Contract #: 04-0120F4Cty: SF/ALA Rte: 80 PM: 13.2/13.9File #: 69.25B**QUALITY ASSURANCE -- NON-CONFORMANCE REPORT****Location:** Changxing Island, Shanghai, China**Report No:** NCR-000798**Prime Contractor:** American Bridge/Fluor Enterprises, a JV**Date:** 13-Jul-2010**Submitting Contractor:** Zhenhua Port Machinery Company, Ltd (ZPMC), Changxing Island**NCR #:** ZPMC-0760**Type of problem:**

Reference Description: Incorrect WPS used on DP3126A Deck Panel**Description of Non-Conformance:**

Dear: Mr. Charles Kanapicki
Attention: Mr. Thomas Nilsson Project/Fabrication Manager
Subject: NCR No. ZPMC-0760

Job Name: SAS Superstructure
Document No: 05.03.06-000756

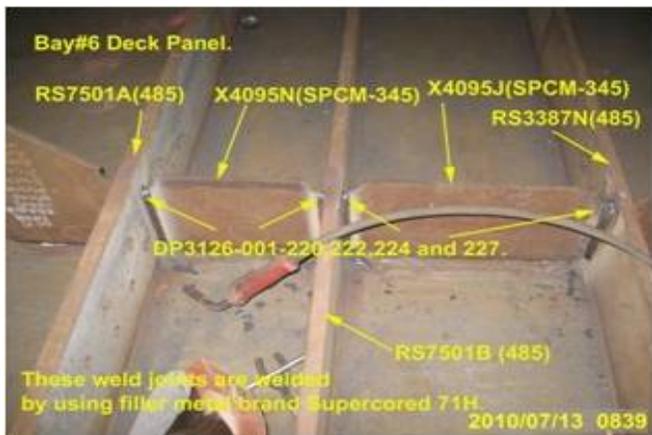
During a random in process inspection of Orthotropic Box Girder (OBG) Deck Panel (DP) DP3126A, Quality Assurance (QA) discovered the following issue:

-ZPMC welding personnel performing Flux Cored Arc Welding (FCAW) using a WPS that is not approved for the joint being welded.

-The welding was being performed to WPS-B-T-2133 which specifies A709-345 to A709-345 material using filler metal brand Supercored 71H Class E71T1.

-The material being welded was A709-Gr345 to A709-HPS-485W.

-The welds are fillet weld T-joints, joining Seismic Performance Critical Material (SPCM) diaphragms identified as X4095N and X4095J to Rib Stiffeners identified as RS7501A/B and RS3387N/M.

-The weld joints are identified as DP3126-001-139~142,149,150,153,154,220,222,224 and 227.

Reference Resolution: ZPMC is providing NDT documentation to show that the welds are acceptable after being welded using the correct WPS.

ZPMC has removed the welds that were welded using the incorrect WPS and filler metal in accordance with the approved CWR. ZPMC is providing NDT documentation to show that the welds are acceptable after being welded using the correct WPS. In this instance, ZPMC production began work prior to the CWI arriving which would have prevented this non conformance. ZPMC QA has warned the production department and the production team leader that welding without a CWI is unacceptable and has written an internal NCR to document the non conformance and is working with ABFJV to ensure that production areas are being monitored for welding activity so CWIs are present. Based on this ZPMC requests closure of this NCR.

The proposed resolution is acceptable. This NCR is considered closed.

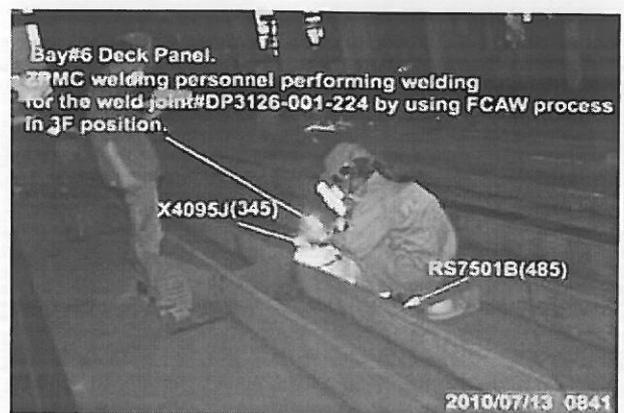
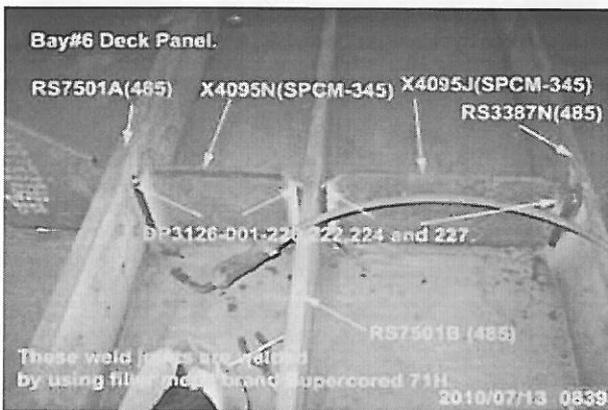
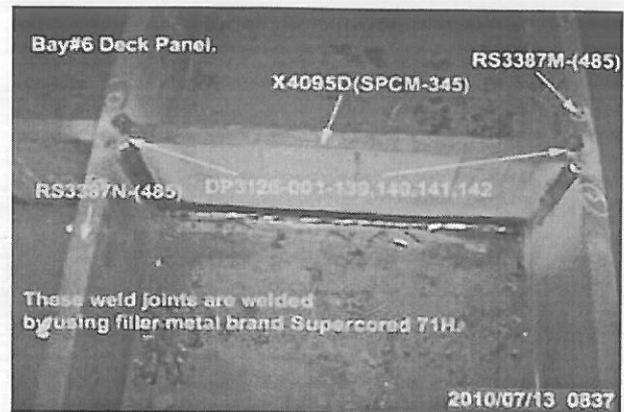
During a random in process inspection of Orthotropic Box Girder (OBG) Deck Panel (DP) DP3126A, Quality Assurance (QA) discovered the following issue:

-ZPMC welding personnel performing Flux Cored Arc Welding (FCAW) using a WPS that is not approved for the joint being welded.

-The welding was being performed to WPS-B-T-2133 which specifies A709-345 to A709-345 material using filler metal brand Supercored 71H Class E71T1.

-The material being welded was A709-Gr345 to A709-HPS-485W.

-The welds are fillet weld T-joints, joining Seismic Performance Critical Material (SPCM) diaphragms identified as X4095N and X4095J to Rib Stiffeners identified as RS7501A/B and RS3387N/M.

-The weld joints are identified as DP3126-001-139~142,149,150,153,154,220,222,224 and 227.

Remove and replace welds in question and perform NDT required to verify weld quality.

Said welds were removed and replaced. Contractor has submitted subsequent NDT records verifying welds meet Contract weld quality requirements. An internal NCR was also issued in regards to this issue.
